CALIFORNIA REGIONAL WATER QUALITY CONTROL BOARD  
CENTRAL VALLEY REGION

ORDER NO. R5-2014-XXXX

CEASE AND DESIST ORDER,  
RECOLOGY'S PROPOSED MARKUP (with Explanatory Notes) (Aug. 18, 2014)  
REVISION DATED 8/13/14

FOR  
RECOLOGY HAY ROAD  
JEPSON PRAIRIE ORGANICS AS A DBA OF RECOLOGY HAY ROAD  
RECOLOGY HAY ROAD LANDFILL  
SOLANO COUNTY

Table 2  
 Groundwater Elevations  
 First and Second Quarters 2014  
 Recology Hay Road

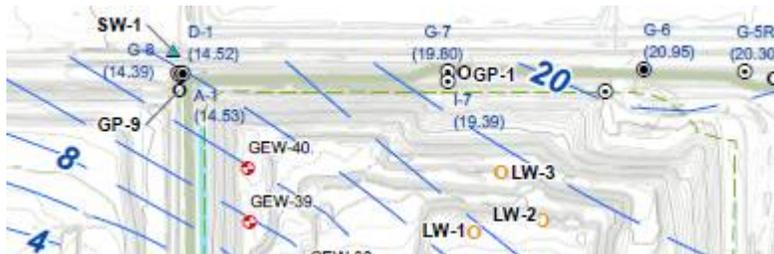
First, contrary to the claims by RWQCB staff, groundwater elevations are measured to 0.01 feet. The measured elevations are presented to the RWQCB in each semiannual

monitoring report in both tabular form and on the groundwater elevation contour maps. Examples of each are presented below:
